**Staff Report  
BOA-23921**

1546 South Harvard Avenue  
Tract Size: ±0.14 acres

<b>Project Name:</b>	16th & Harvard - ADU
<b>Date:</b>	7.18.2025
<b>Response By:</b>	Cody Rogers cDesign, LLC. PO Box 576 Mounds, OK 74047 918.809.6813 cdesignhomes@gmail.com

<b>Plan Corrections Summary:</b>	BLDR-210056-2025 (1546 S HARVARD AVE E Tulsa, OK 74112) Markup Summary #1
<b>Project Name:</b>	16th & Harvard - ADU
<b>Application Number:</b>	BLDR-210056-2025
<b>Plans Examiner:</b> Architectural	George Goza City of Tulsa - Development Services 175 East 2nd Street, Suite 450 Tulsa, OK 74103 918.576.5405 ggoza@cityoftulsa.org
<b>Plans Examiner:</b> WSD	James Henley City of Tulsa - Development Services 175 East 2nd Street, Suite 450 Tulsa, OK 74103 918.596.7344 jameshenley@cityoftulsa.org
<b>Plans Examiner:</b> Zoning	Danny Whiteman City of Tulsa - Development Services 175 East 2nd Street, Suite 450 Tulsa, OK 74103 918.596.9664 dwhiteman@cityoftulsa.org
<b>Corrections Summary:</b> Received Date	4.18.2025
<b>Corrections Summary:</b> Response Date	5.6.2025
<b>Response By:</b>	Cody Rogers cDesign, LLC. PO Box 576 Mounds, OK 74047 918.809.6813 cdesignhomes@gmail.com

1 MAIN LEVEL FLOOR PLAN  
3/8" = 1'-0"

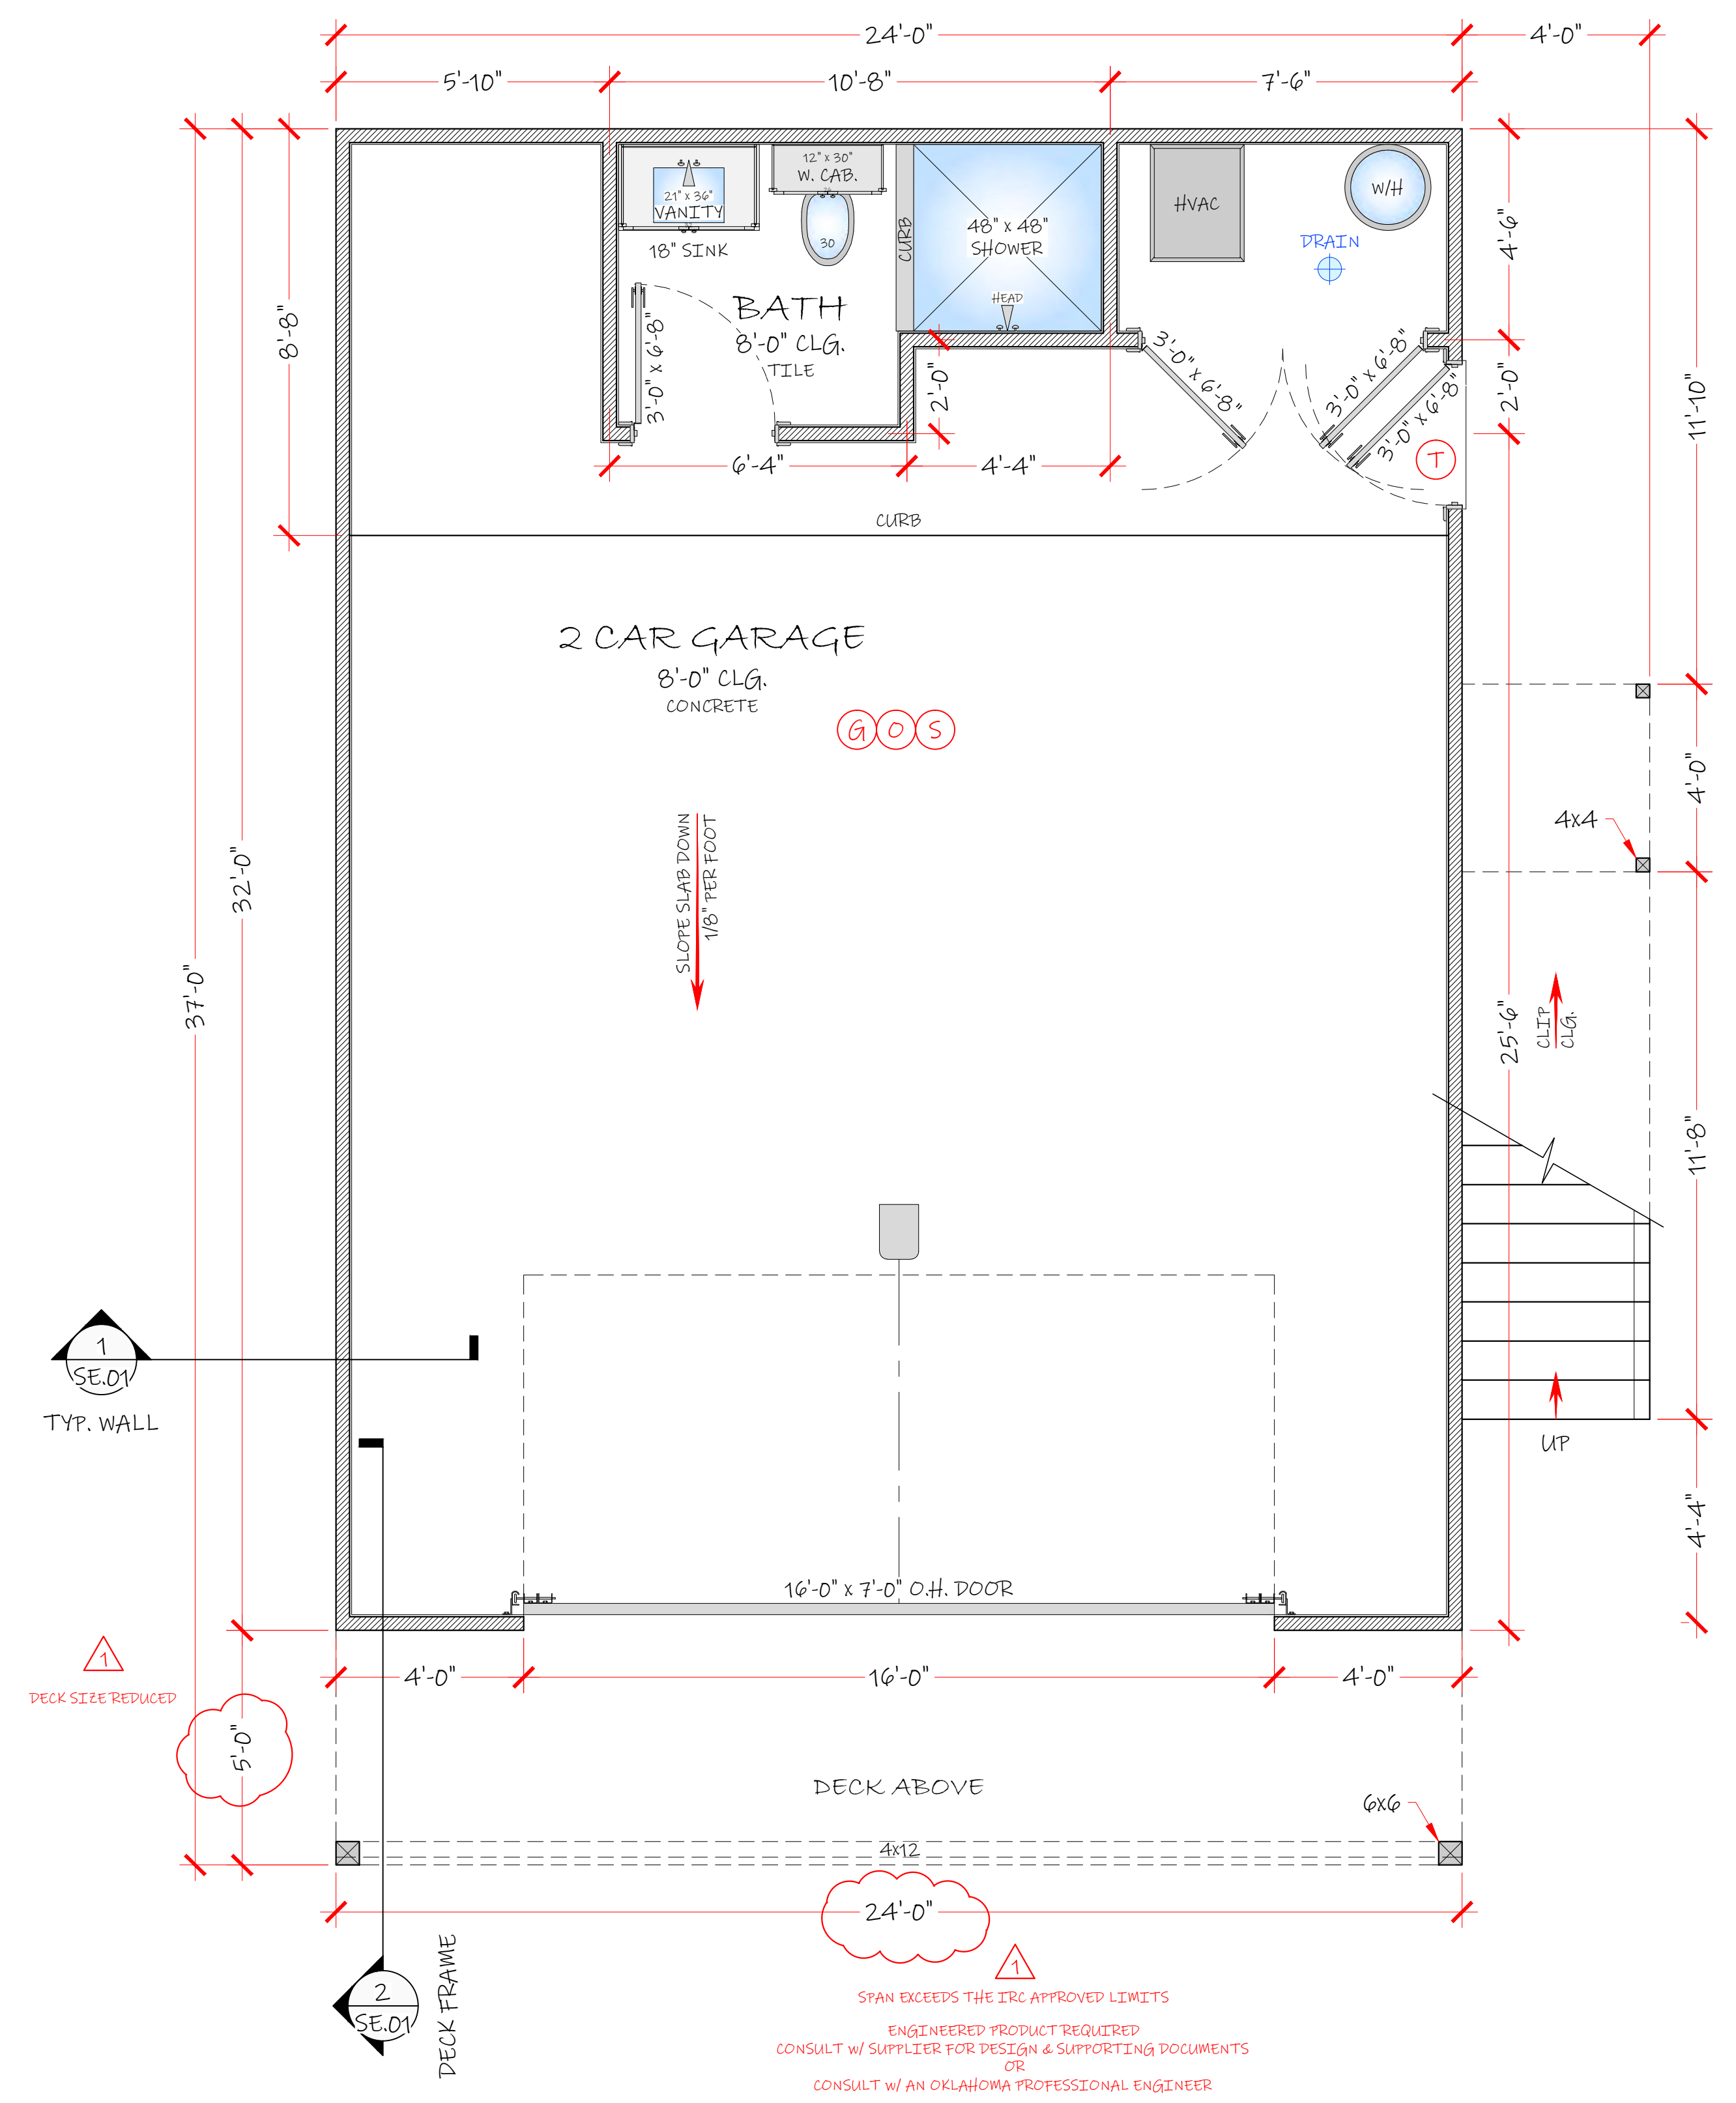
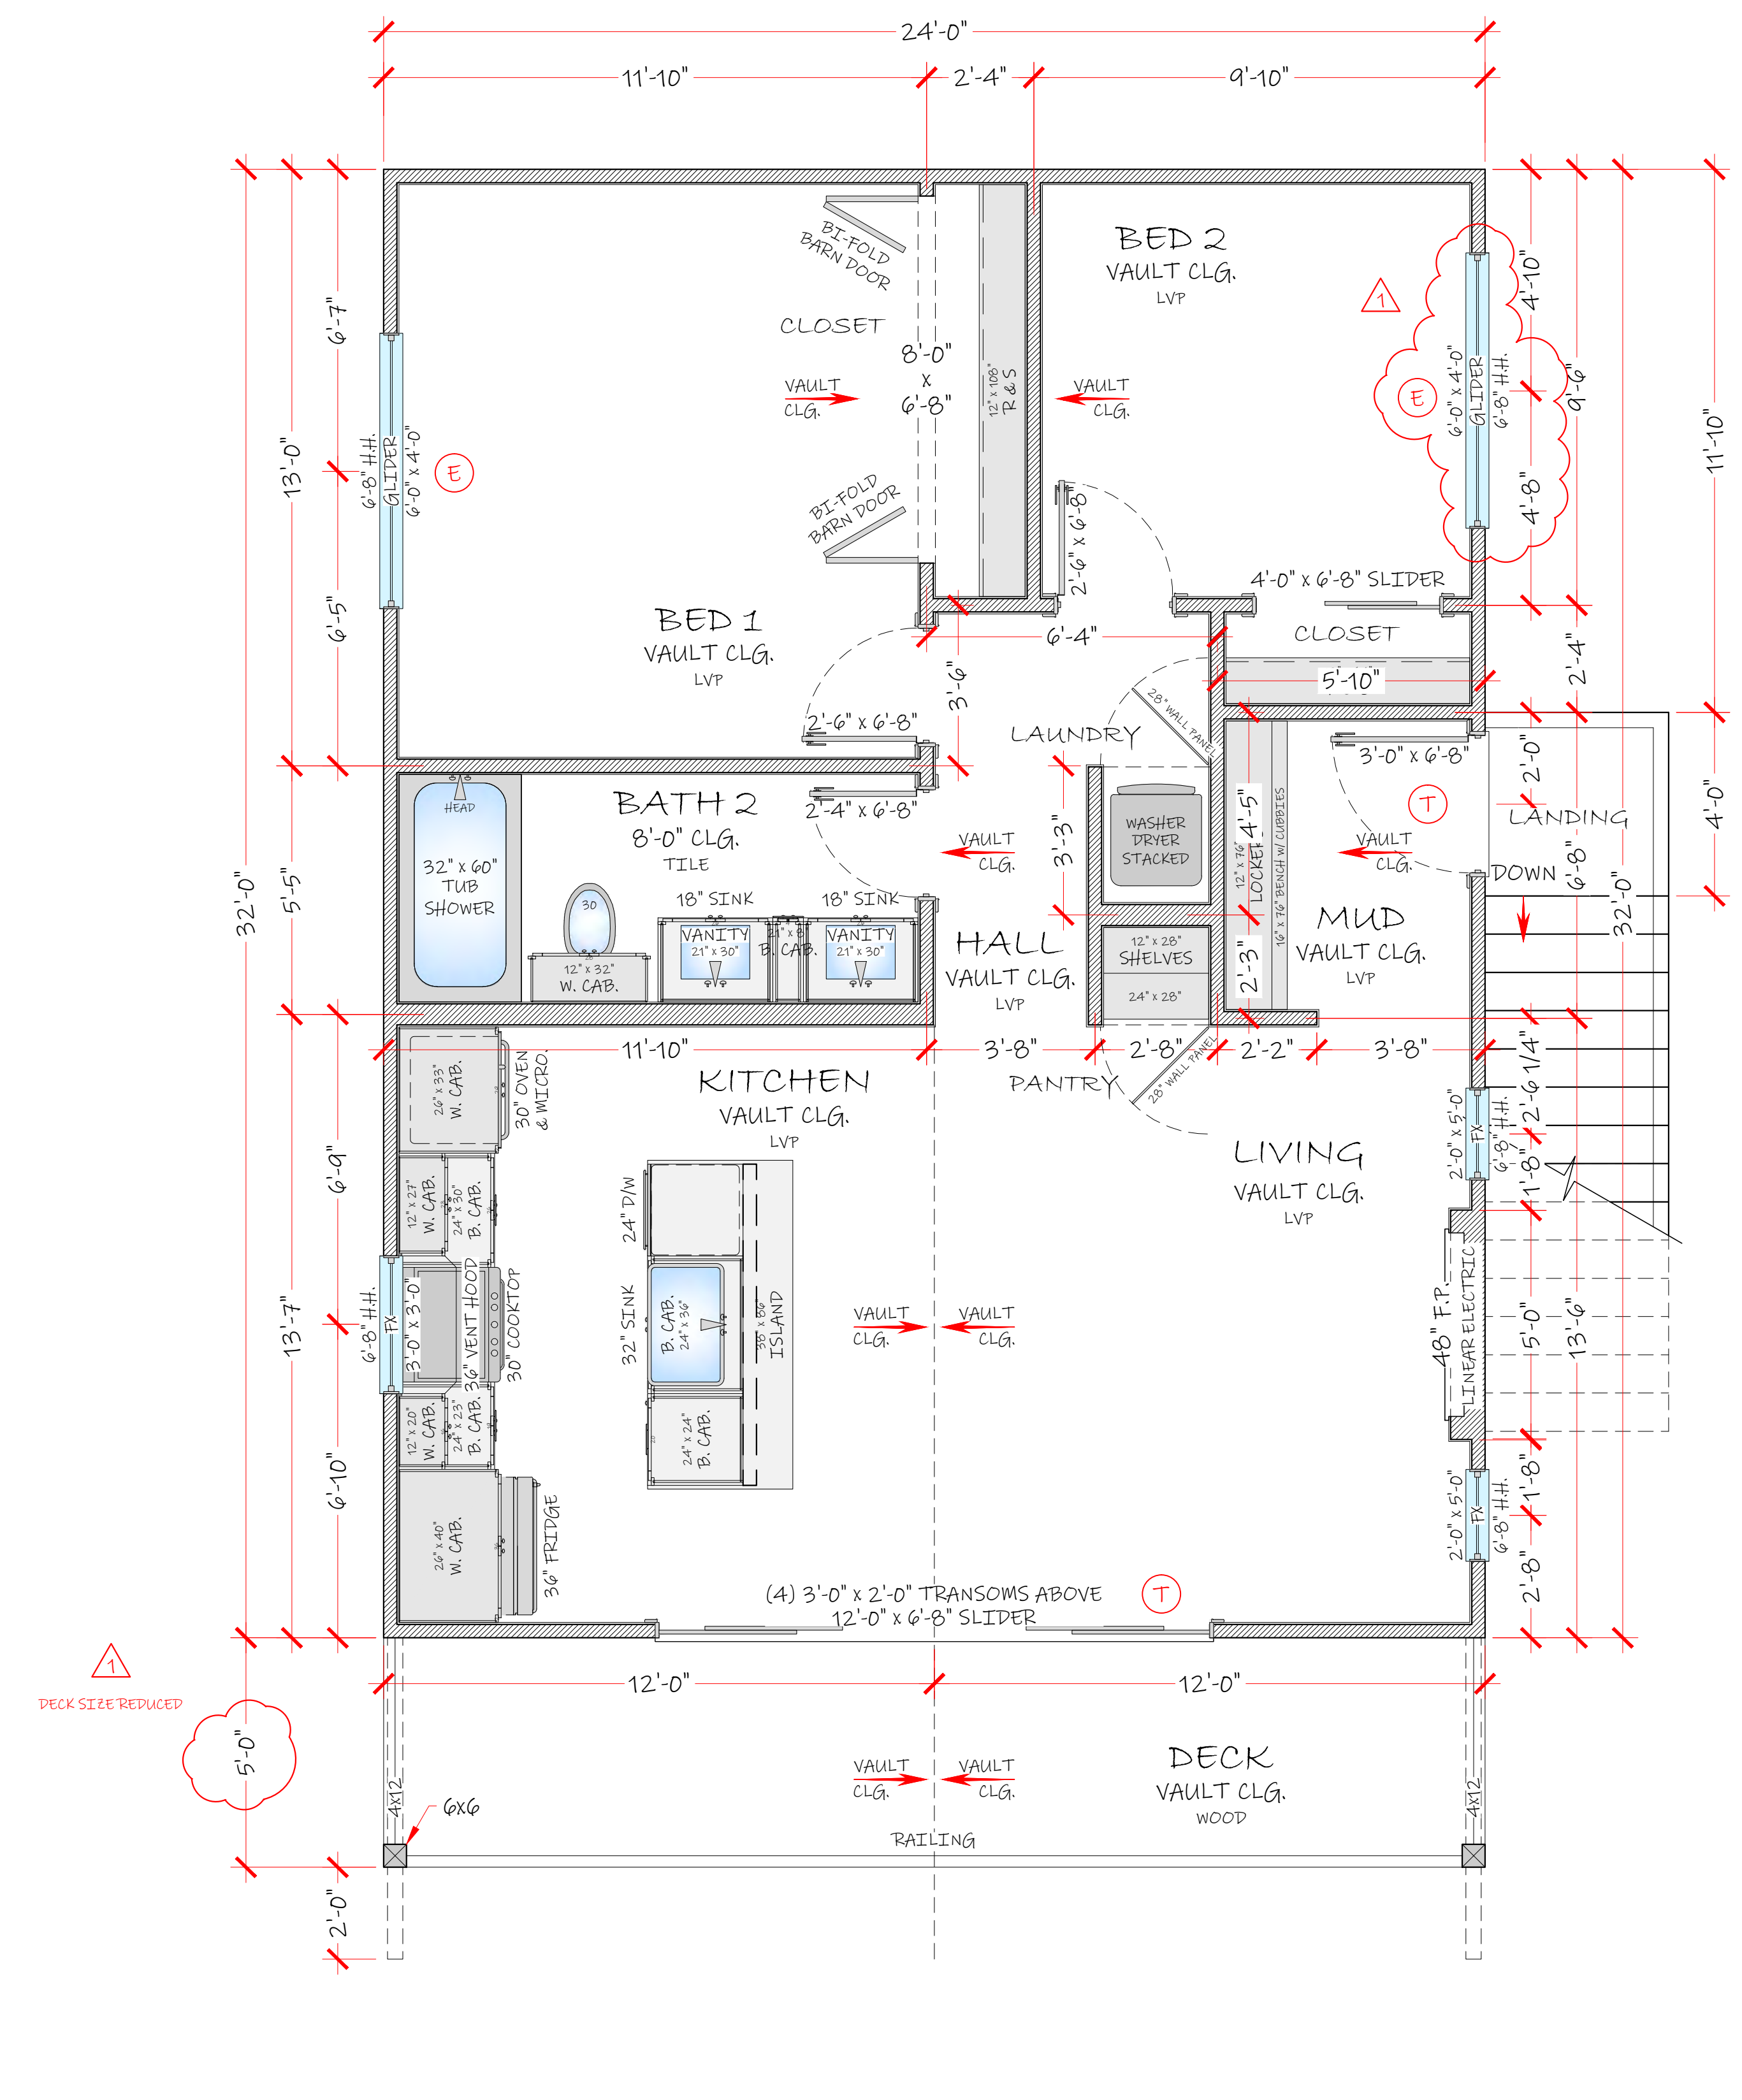
*The span for the deck beam(s) appears to exceed the limits of Table R507.5 permitted for prescriptive construction (Section R301.1.3). Please provide an engineered product with support information meeting the proposed design or a design sealed by an Oklahoma Professional Engineer. This is regarding the front upper exterior deck with a beam span of approximately 24-feet.*

*Any windows on the second level within 10' of the rear or side property line need to have permanently translucent glazing or have a minimum sill height of 6 feet above the finished floor. Please revise plans accordingly, keeping in mind that the required emergency escape opening windows in bedrooms must have a sill no more than 44" off of the floor.*

Refer to revised sheet FP.01 - Main Level Floor Plan. The deck beam has been notated for an engineered product design with [supporting documents to be provided](#).

Refer to revised sheet SP.01 - Site Plan & revised sheet FP.01 - Upper Level Floor Plan. The building has been repositioned and now exceeds the required set back of 10' from the West property line. On the North property line, Lots 11 & 12 are not to be combined and therefore the second story bedroom egress window was relocated to the East wall.
